**FINAL****ENVIRONMENTAL  
IMPACT  
STATEMENT****PROPOSED DEVELOPMENT  
OF OIL SHALE RESOURCES****VOL II**

**The Colony Development Operation  
in Colorado****U.S. Department of the Interior  
Bureau of Land Management**

CHAPTER X  
CONSULTATION AND COORDINATION

Figure 17  
COLORADO RIVER MILE MAP

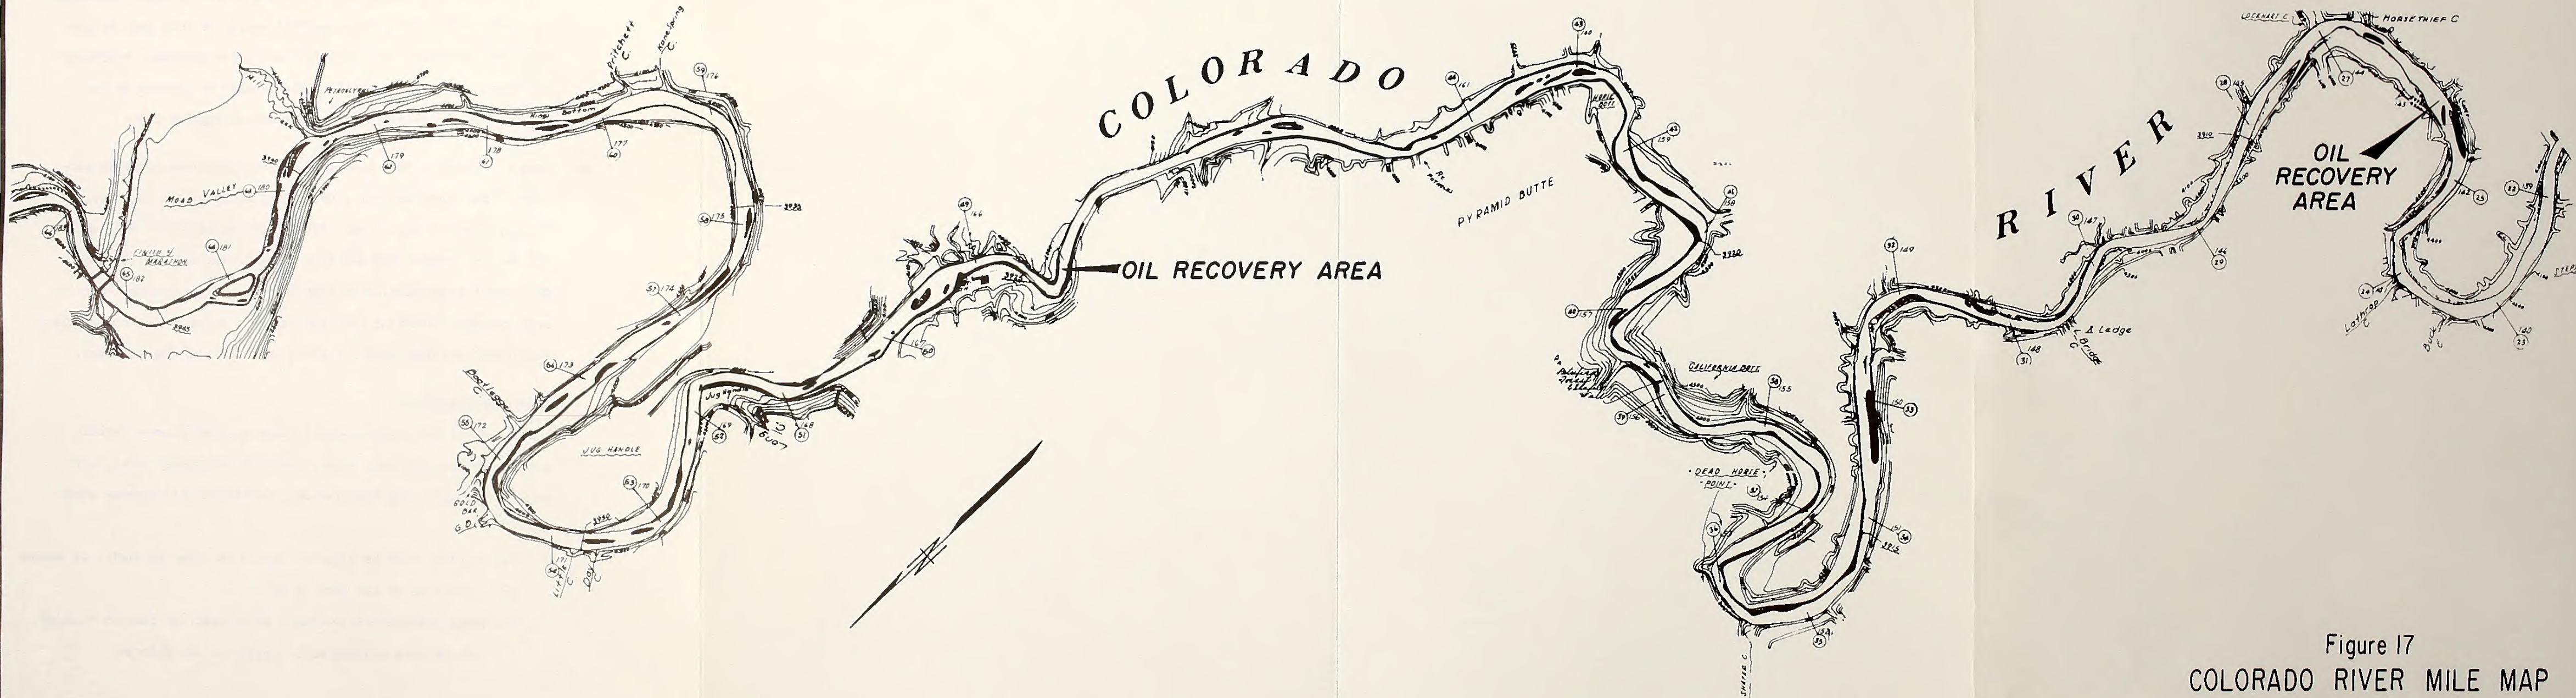
The park boundary should be indicated in Figure 17 for information purposes.

While it is true that small earth-moving equipment can be brought in via the Lathrop Canyon jeep road (see page E-20) the equipment cannot be utilized in the recovery operation without inflicting severe, long-term physical damage to the environment. We do not feel that the relatively short-term (though severe) impact of an oil spill would justify drastic alteration of the physical environment. In addition, the topography is such that valuable time would be lost in constructing access from Lathrop Canyon to the actual recovery site almost two miles upstream (see Figure 17.)

Figure 25. Accessible recovery locations inside Arches Park.

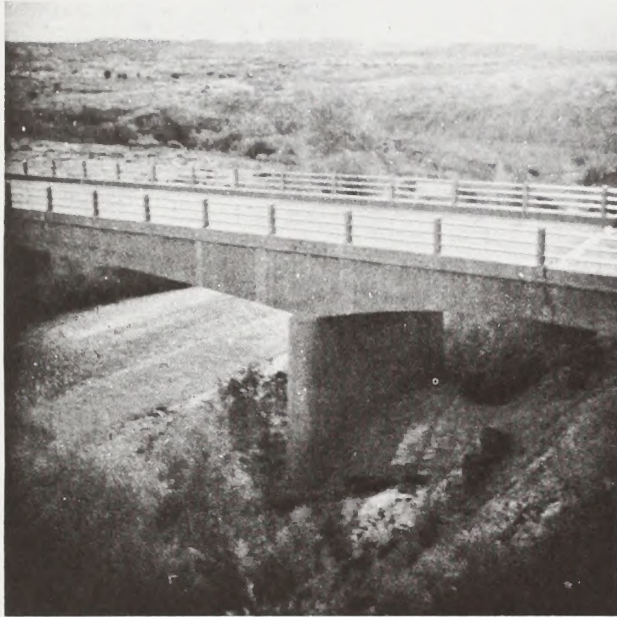
1. Figures 14 and 25 show an oil spill recovery site on Salt Wash at Wolfe (Turnbow) Cabin. The final statement should address the fact that this is a National Register property, establish what the impact of the project will be upon it, and how any adverse effects are to be mitigated.

2. Figures 14 and 25 designate two primary recovery sites within Arches: Wolfe Cabin and where the main park road crosses Courthouse Wash. The primary recovery sites should be outside the park and proposed wilderness so that spill entry into the park can be prevented if at all possible. Perhaps the problem is partly one of terminology, but there should be emphasis and planning to prevent oil spill entry into the park if at all possible.
